Re: GLOUCESTER – Solid Waste Management
Eastern Waste Services, LLC
24 Kondelin Road
FMF#: 364665

BWP SW01/Site Suitability for a New Site Assignment
Application Number: 23-SW01-0002-APP

On behalf of Eastern Waste Services (EWS), Tetra Tech is responding to MassDEP technical review comments received in regard to the Site Assignment Application #23-SW01-0002-APP (Application).

**PROPOSED RESIDENTIAL RECYCLING AREA
OPTION 1**

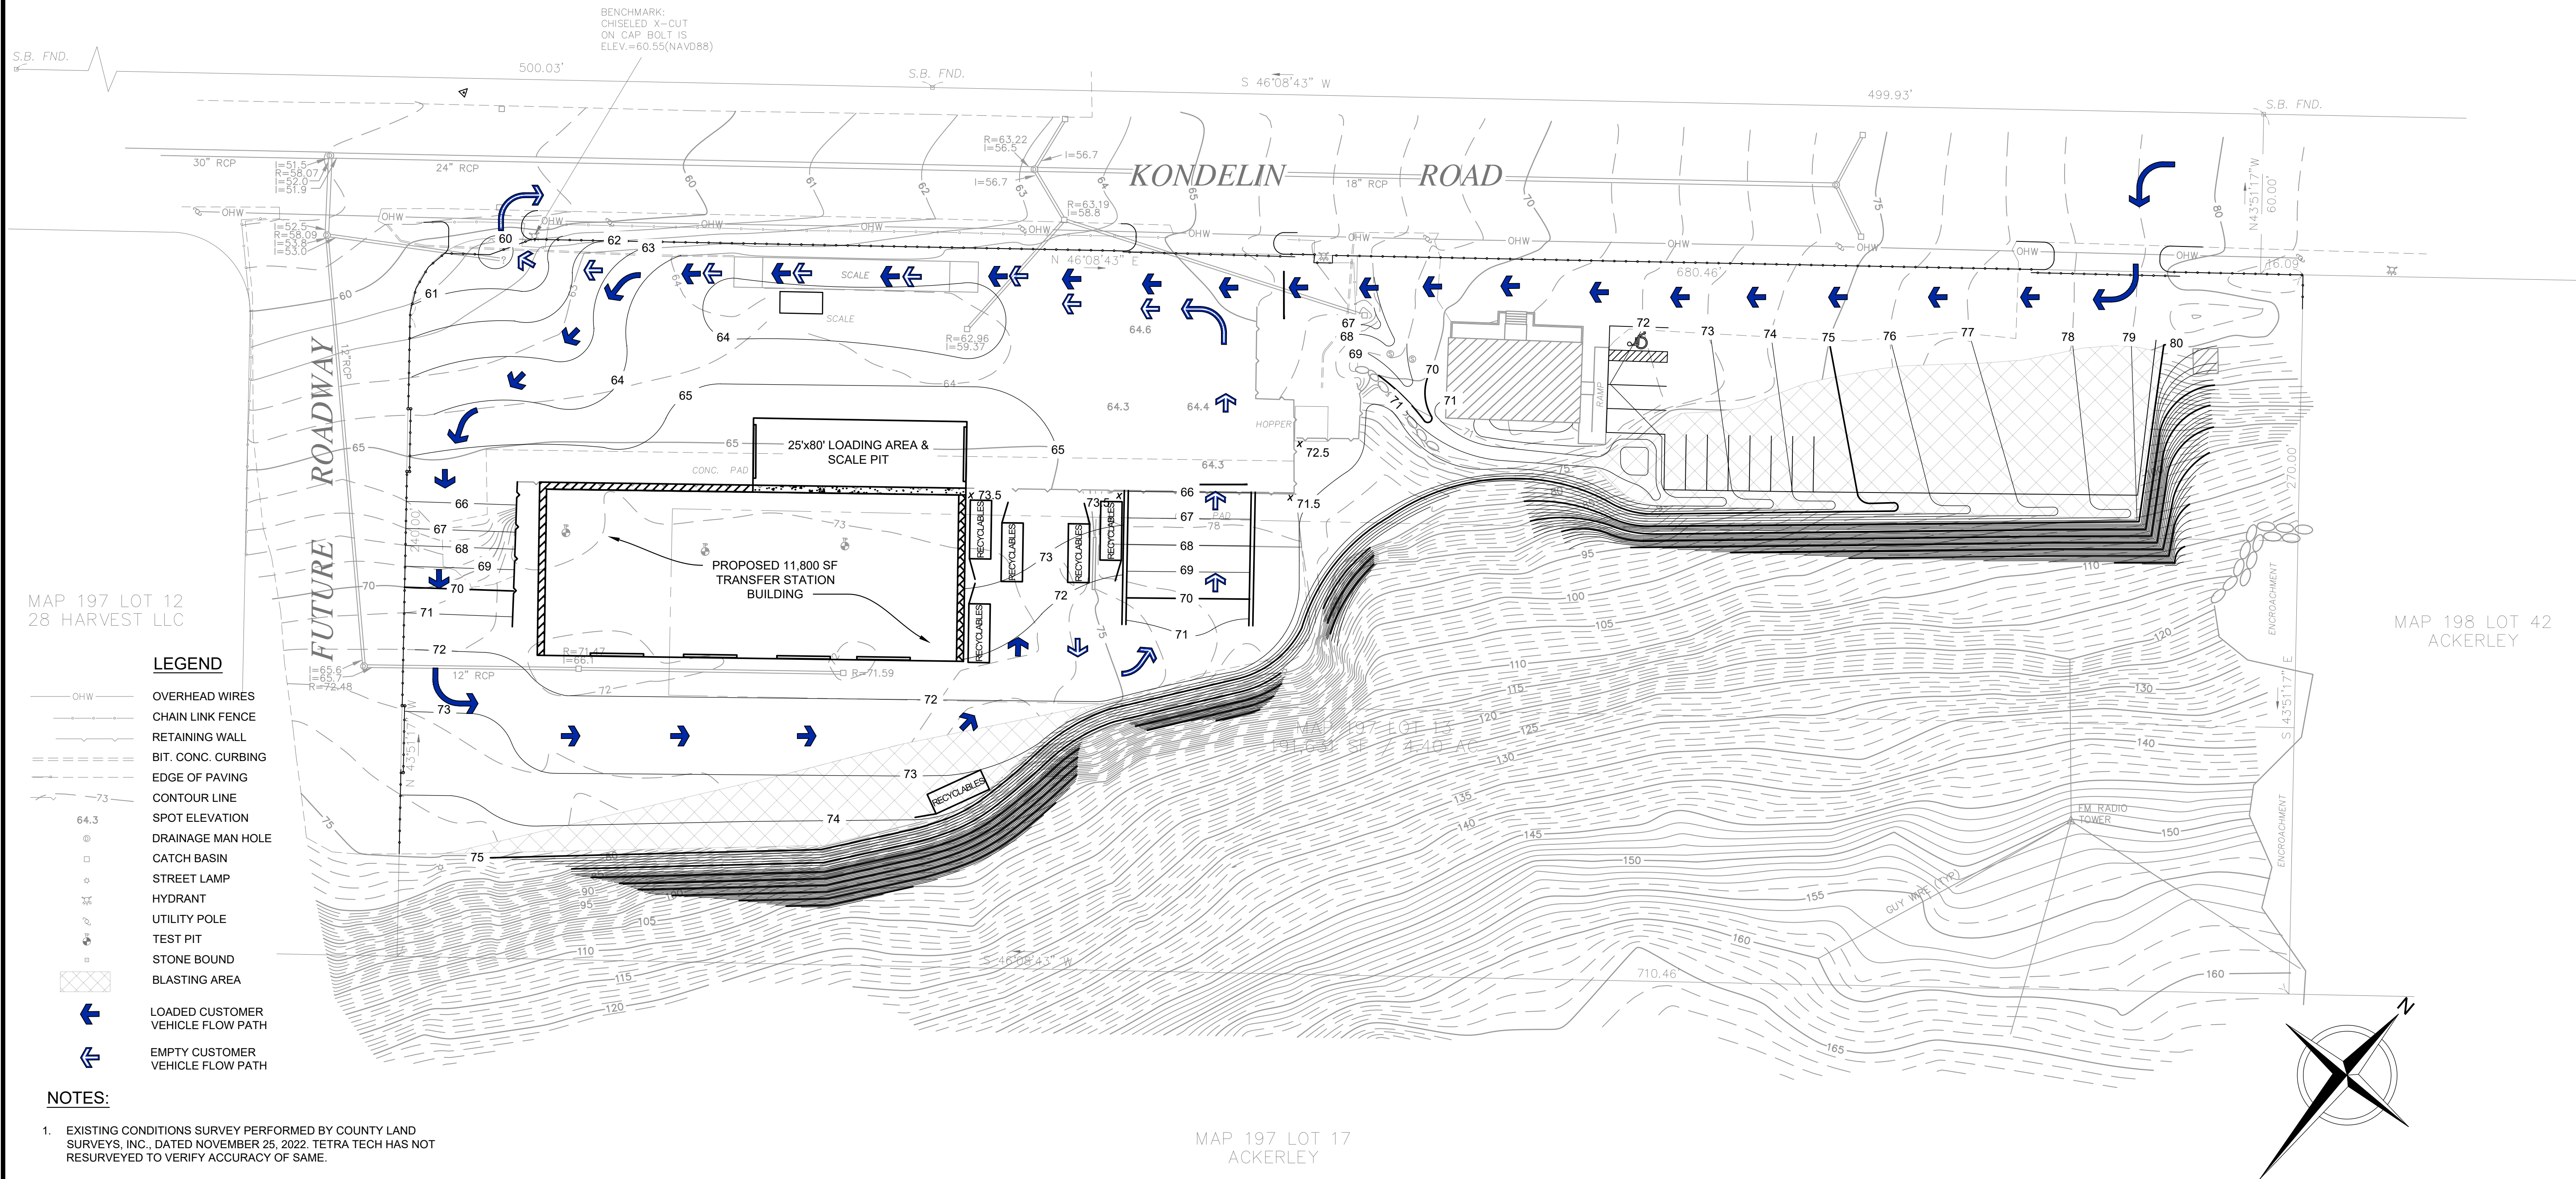
Additionally, MassDEP has asked us to include options for the residential recycling area with the conceptual site plan submissions. We have included two (2) options in Attachment E for your review. For each option, we assessed vehicle movement, traffic flow, and the convenience for residents to unload and deposit their recyclables into the designated containers. Additionally, we demonstrate the operations of the proposed residential recycling area operations. Each container will have clear signage and instructions, as well as staffing to oversee residential unloading. The Facility will operate up to 6 days per week, 12 hours per day but it is expected that unloading of residential vehicles typically will be restricted to Saturdays between 6:00 a.m. and

12:00 p.m. As shown in Options 1 and 2, residents will enter and exit using the same traffic pattern as typical commercial traffic. The property is currently operating in a similar manner for the acceptance of residential recyclable materials and this type of traffic is part of the existing conditions.

EWS is also mindful of the possibility that residents might have C&D waste material to unload at the Facility. Should residential vehicles with C&D waste materials unload within the transfer station building, other vehicular and machinery movement will be restricted until residents have left the Facility Tipping Floor. While residents will be encouraged to utilize the Facility during dedicated residential hours on Saturdays between 6:00 a.m. and 12:00 p.m., EWS intends to accommodate residential customers at other times provided that adequate staffing is available to safely oversee residential vehicle maneuvering.
